PRELIMINARY PLAT MAP
OF
NORMANDY HEIGHTS - PDR
PTN OF THE SE1/4, OF THE SE1/4 OF SEC. 35, 20 N., RGE 4 E., W. M.
CITY OF PUYALLUP, PIERCE COUNTY, WASHINGTON STATE

PRELIMINARY CIVIL PLANS
NORMANDY HEIGHTS - PDR

Job Number
12663

Sheet
2 of 12

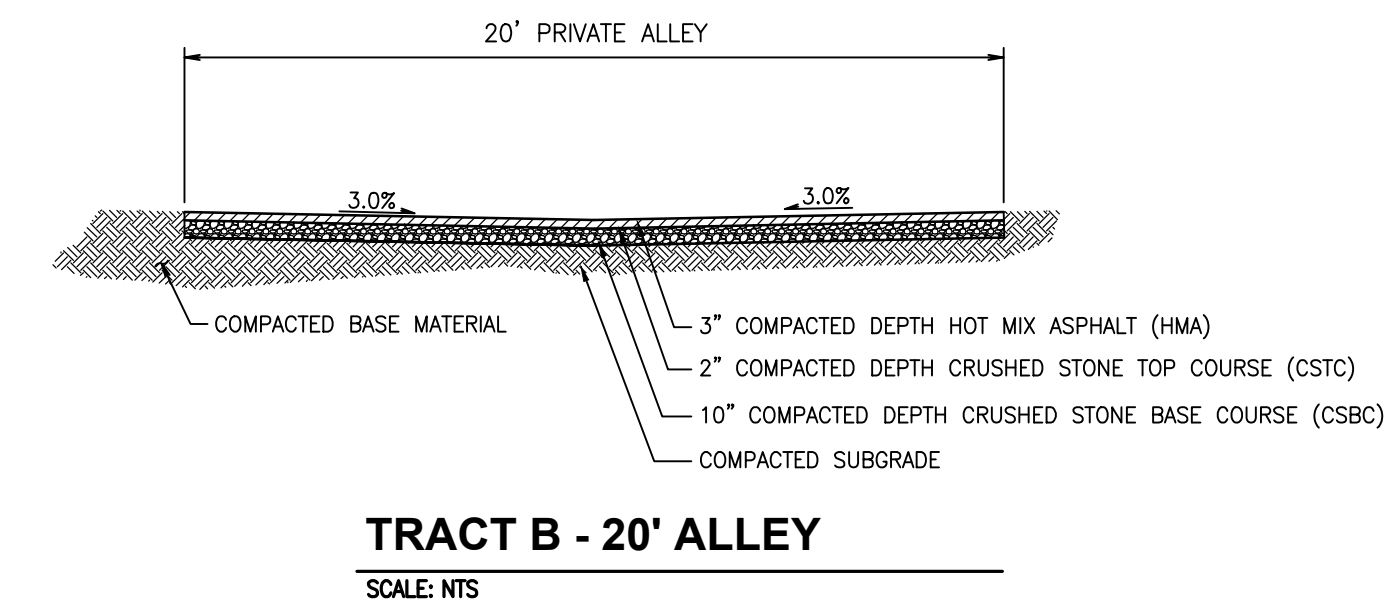
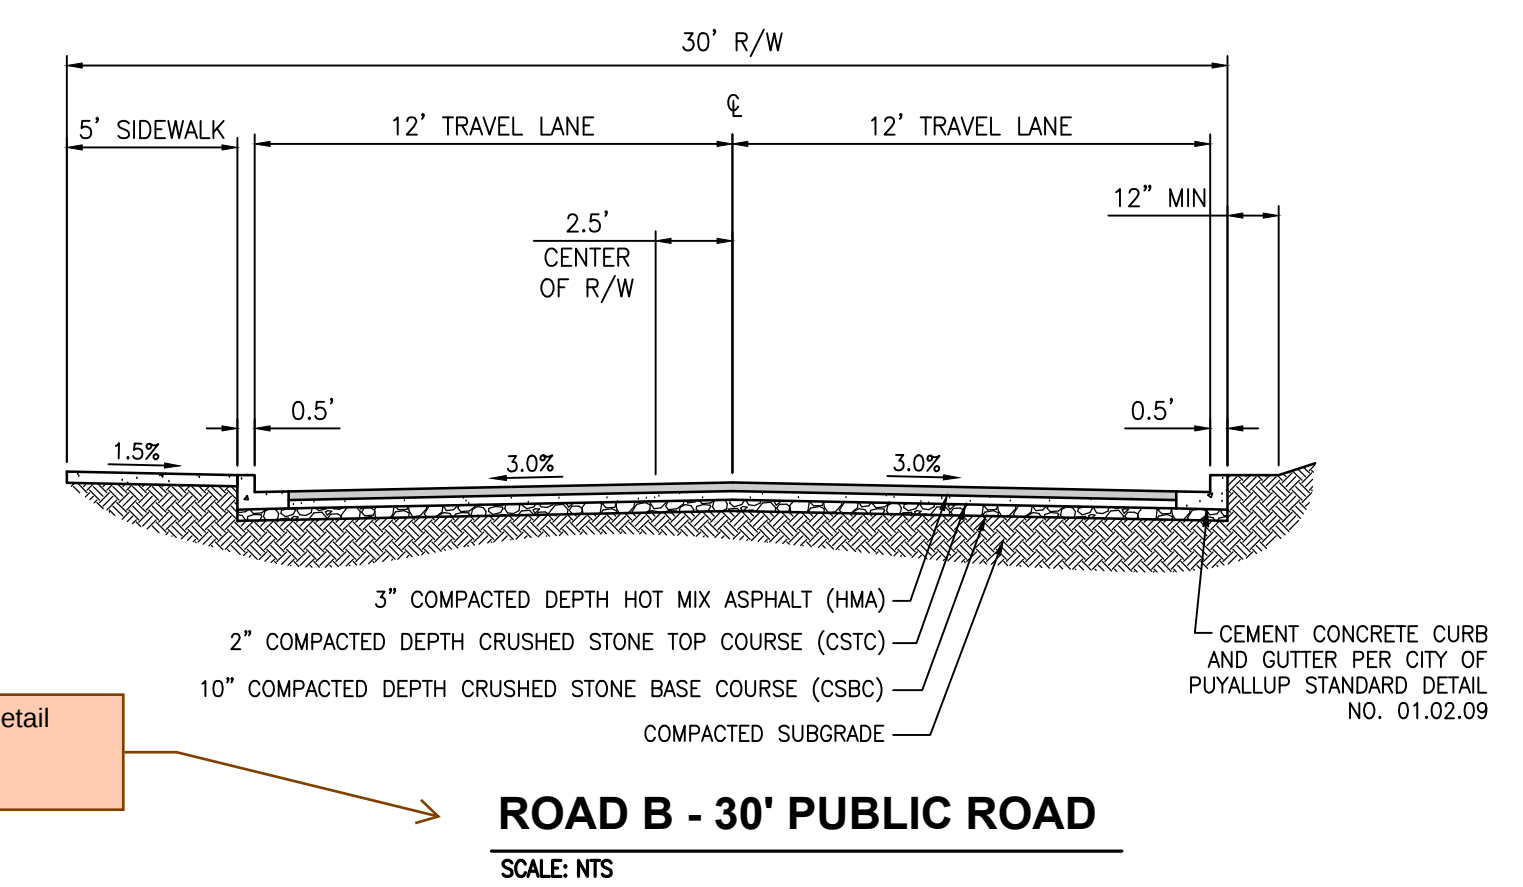
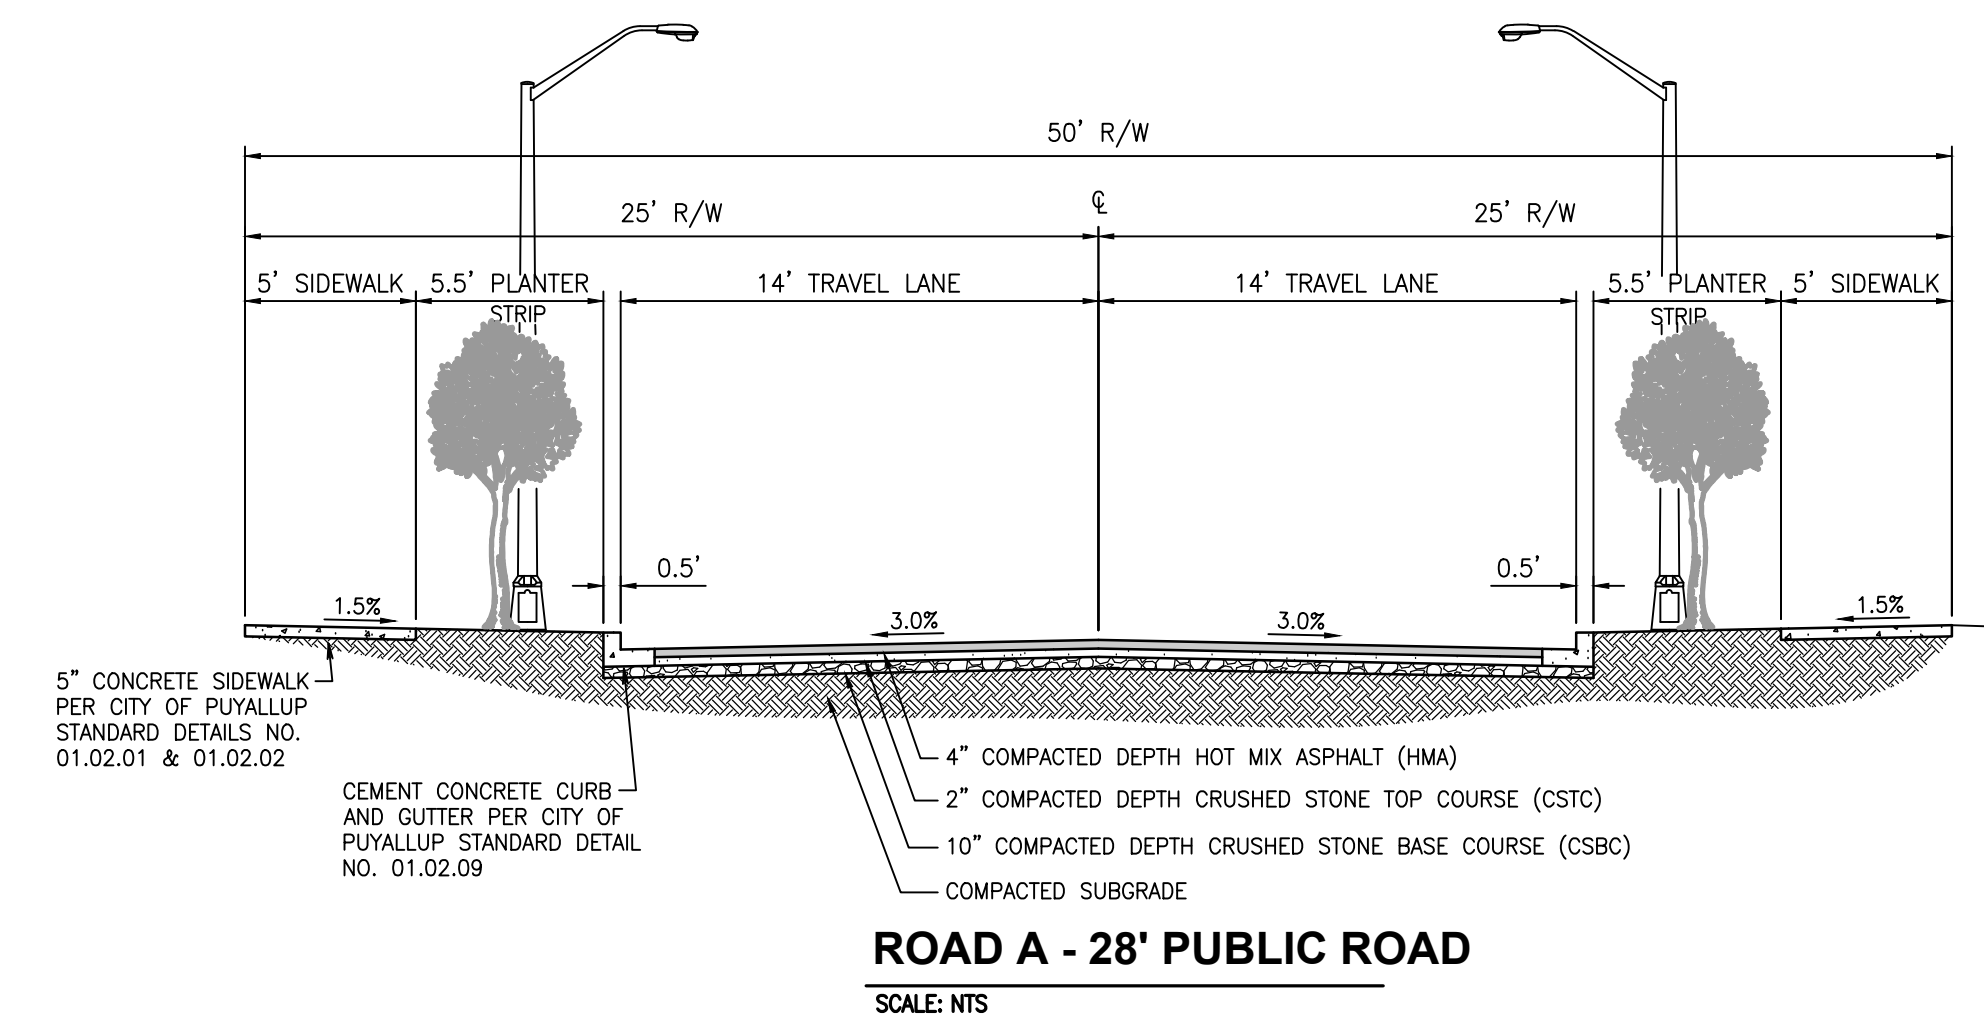
Where did this standard detail come from?
Preliminary Plat Sheet 2

Job Number
12663
Sheet
4 of 12

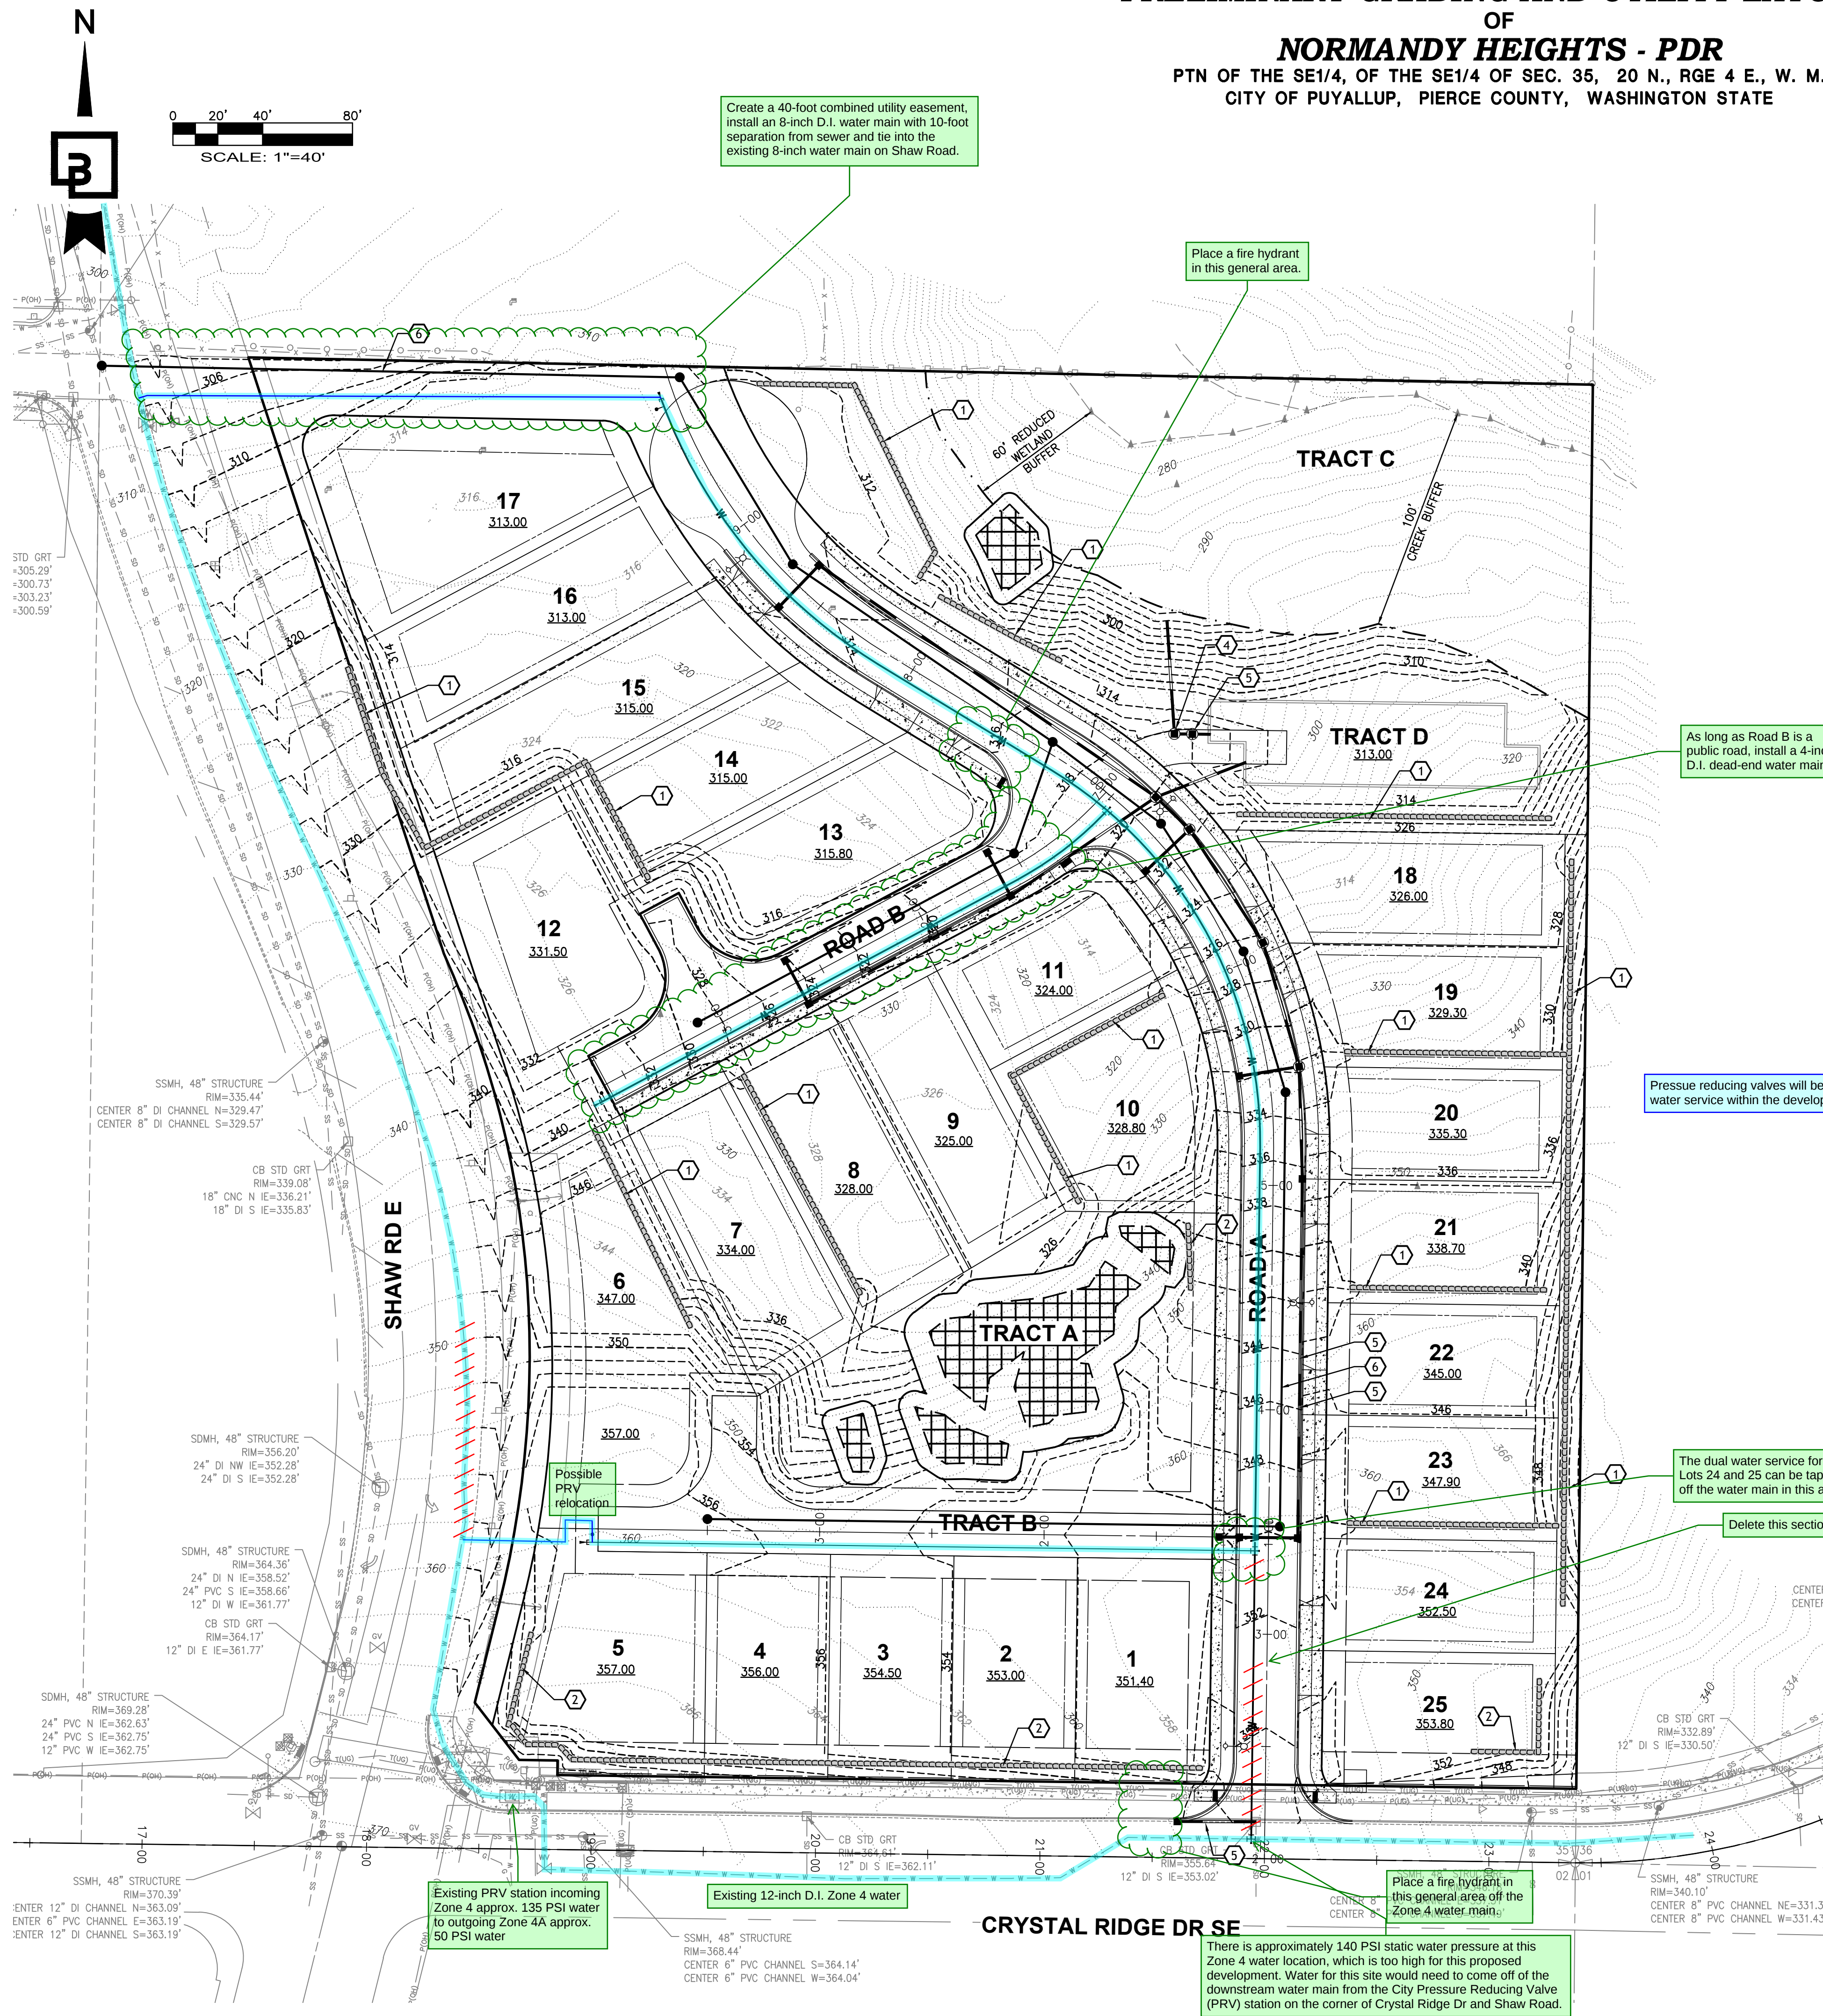
Similar to the previous submittal, walls must be located on private property. Per previous coordination with the City, grading must be provided along the Shaw Rd frontage. Top of wall must be a minimum 1-ft above proposed Shaw Road finished grade.

Previous Planning Comments regarding retaining walls do not apply to these walls proposed along the plat boundaries. Planning incorrectly understood the proposed walls along the plat boundary to be positioned several feet above the road rather than several feet below the road. Disregard all comments referencing PMC 20.50.005.

The city is in agreement that obligations for Normandy's frontage improvements along Shaw Road will be met with ROW dedication, rough grading of shoulder area from existing pavement to the proposed retaining walls, and the construction of the retaining walls based on a wall design agreeable to the city. It will be Normandy's responsibility to design, permit, and construct the walls as well as implementing any mitigation if any is identified during the permitting process (I'm thinking if the wall design encroached on a wetland). With the fulfillment of these obligations, no further payment of fee in lieu will be necessary.
